**PRODUCT
SUPPORT
BULLETIN # 344**

5460, 5540 7" / 9" Polisher

6076, 6078 7" / 9" 13Amp Sanders

SUBJECT: Armature 'rubbing / dragging' on Field

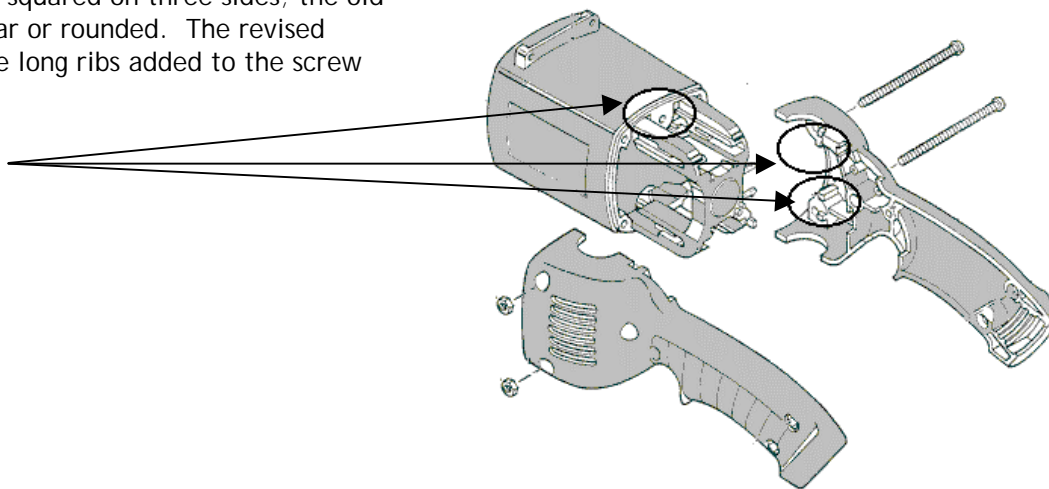
A occasional complaint of a 5460, 5540 7" / 9" Polisher with it's Armature 'rubbing / dragging' on the Field laminations is caused when the two handle screws closest to the motor housing are tightened down; this distorts the motor housing allowing for the possibility of the armature & field to come into contact with each other.

31-50-0548 Motor Housing, along with the **31-44-1771** Left Handle Half & **31-44-1776** Right Handle Half have been revised and have had ribs / material added. The added material prevents the twisting of the motor housing and eliminates the problem when the two handle screws are tightened.

The field screw-mounting pads of the revised motor housing are squared on three sides; the old version was circular or rounded. The revised handle halves have long ribs added to the screw hole area.

Both a 31-50-0548 Motor Housing & the Handle Halves 31-44-1771 & 31-44-1776 need to be replaced to properly correct the problem.
